**COMMISSION OF ARCHITECTURAL REVIEW  
STAFF REPORT  
September 26, 2017, Meeting**

1. **COA-021095-2017** (Homes REI)

**727 North 22<sup>nd</sup> Street  
Union Hill Old and Historic District**

**Construct a two-story addition,  
restore front porch.**

Sanborn Map, 1905

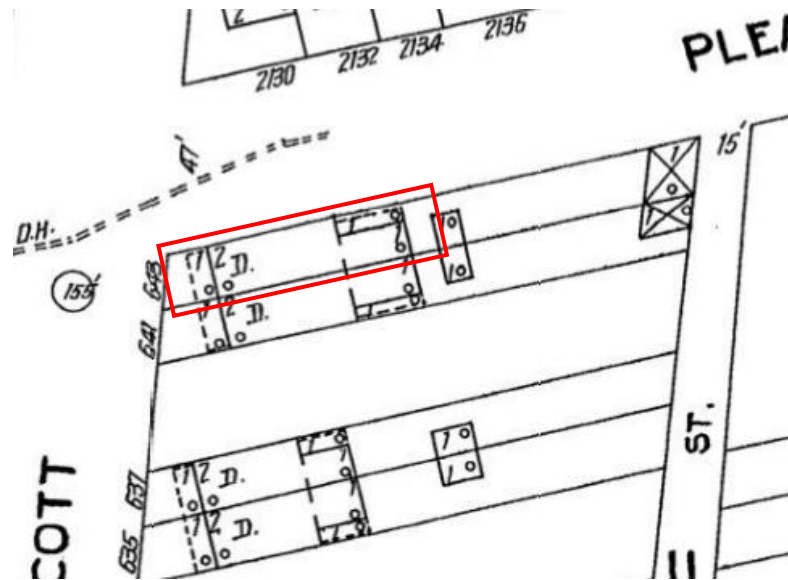
**Rear addition:** Staff continues to have concerns regarding the demolition of a portion of the existing structure and the proposed addition. However, the Commission did not voice similar concerns but rather wished to see the addition stay within the footprint of the existing structure. The *Guidelines* state that additions should not obscure or destroy original architectural elements (pg. 45, Materials & Colors #1) and that fundamental architectural features should not be removed (pg. 57, #9). The applicant is proposing to demolish the existing rear additions, a portion of which appears in the 1905 Sanborn map.
